MENDOCINO COMMUNITY COLLEGE
MODULAR RELOCATION

ADDENDUM 4

DATE
03/12/2010

TLCD PROJECT NUMBER
09007.00

AP2.4

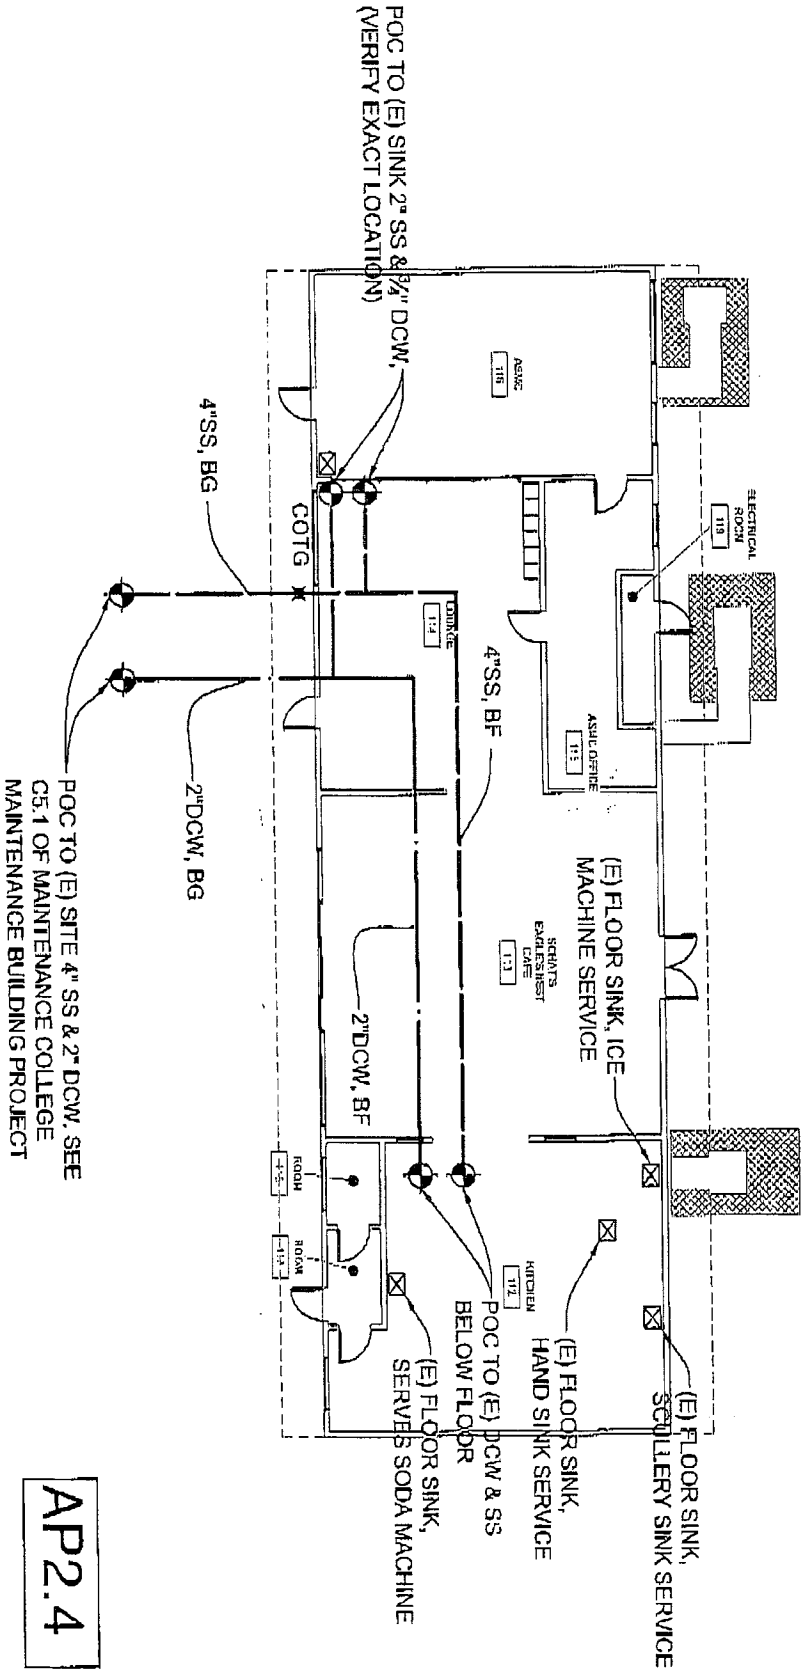
- A. Add new underground cold water piping and point of connections to existing fixtures in Room112 as shown on the attached sheet AP2.4.
 1. Existing Fixtures: 4 floor drains, 2 hand wash sinks and 1 scullery sink
- B. Add new underground waste piping and point of connections to existing fixtures in Room112 as shown on the attached sheet AP2.4.
 1. Existing Fixtures: 4 floor drains, 2 hand wash sinks and 1 scullery sink.
